**Environmental
Planning
Commission**

*Agenda Number: 4
Project #: 2020-003658
SI-2020-00356
Hearing Date: August 13, 2020*

Supplemental Staff Report

Agent	Consensus Planning, Inc.
Applicant	Greystar
Request	1) Major Amendment to Site Plan –EPC
Legal Description	Tracts 1-6 North Andalucia at La Luz Tract 4 North Andalucia at La Luz
Location	SE corner of Coors Blvd. NW and Montano Rd.
Size	Approximately 60 acres
Zoning	PD

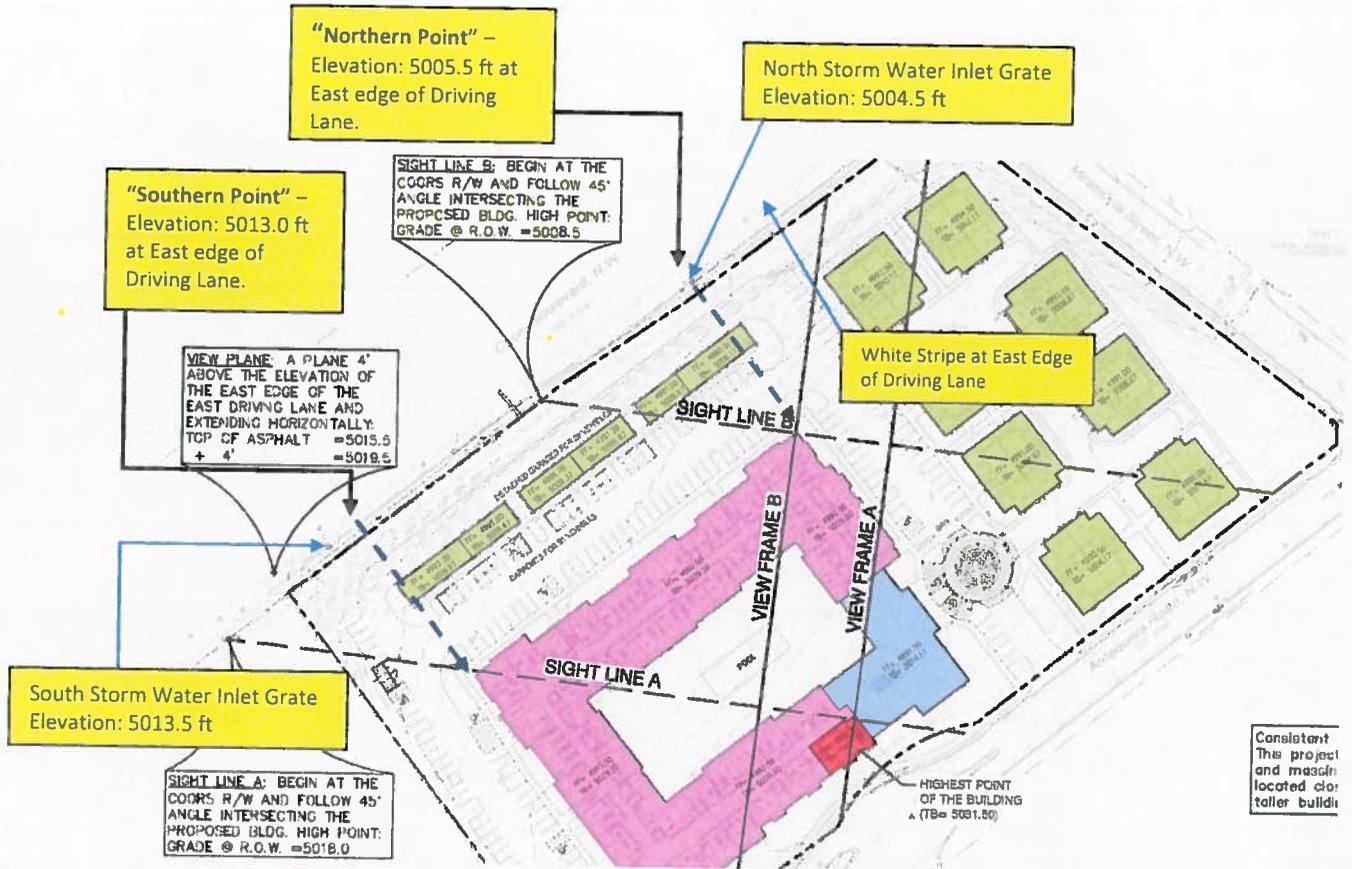
The applicant's engineer provided one "View Plane" building height analysis for the entire length of the three story Overture Andaluca Apartments proposed to be constructed on Coors Blvd. The engineer chose their "View Plane" location along Coors in line with the southern edge of the property, which is the highest spot along Coors in front of the building. We selected two more locations along Coors, where we had elevation data, from which to calculate the allowable height of the proposed buildings. In order to perform our view analysis, we needed the elevation of two spots on the pavement located on the east side of the Coors driving lane in front of the building. We used elevation information provided by the applicant in their submission.

We decided to use the known elevations of two grates covering the storm water inlets shown on the plans in the east driving lane of Coors in front of the building as a basis to establish our test locations. One of these grates is located on Coors slightly south of the southern face of the proposed three story structure and the other grate is very close to being in line with the northern face of the building. We ended up using an elevation on Coors as close as we could determine to be in line with the South end of the building in order to perform the "Southern Point" analysis. We chose to use the storm water grate on Coors near the northern end of the building as the basis for the elevation used for the "Northern Point" analysis. This grate is located in the right turning lane next to the curb. Since the driving lane on Coors is slightly west of this northern grate, we adjusted the elevation of the roadway one foot higher than the grate elevation, to compensate for any drop in elevation from the driving lane to the grate. This grate, as far as we can tell using the maps provided, is very close to being in line with the north end of the building. Note: There is a 9 ft drop in elevation between the two grates, but after our adjustments, the decrease in elevation between the two points we chose to use in the analysis was lowered to 7.5 ft. We included illustrations to help show the information we described above. The IDO allows one third of the building height to project above the view plane.

Both methods used to calculate the View Plane analysis showed that the three story building **FAILS** the view analysis tests at both locations, primarily because a three story building is too tall for the site and the Coors roadway drops nearly 8.5 feet in elevation across the face of the building.

Note #1: The View Plane, as defined on page 103 of the Coors Corridor Sector Plan, "Extends horizontally at 90 degrees to the easterly boundary of the corridor". (Page 103, showing this language, is attached). The View Plane illustration in the IDO shows the structure being evaluated along the entire frontage of Coors using a View Plane 4 feet above the pavement on Coors. Utilizing multiple View Plane locations for the view analysis provides a much clearer picture of a structure's impact on the views.
